TECHNICAL BULLETIN

Product: HDK-79E

Symptom: Vertical lines in picture at high operating temperatures

Diagram 2.

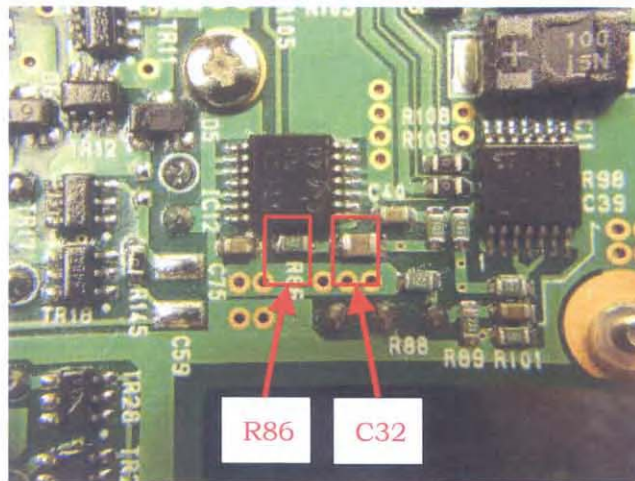
1,Remove CCD PULSE Module from Camera.

2,Please check Installed Resistor(R86) and Capacitor(C32) value.

R86:220 ohm (221)

C32:22p (Capacitor has no information value on it. Than Please check installed or not)
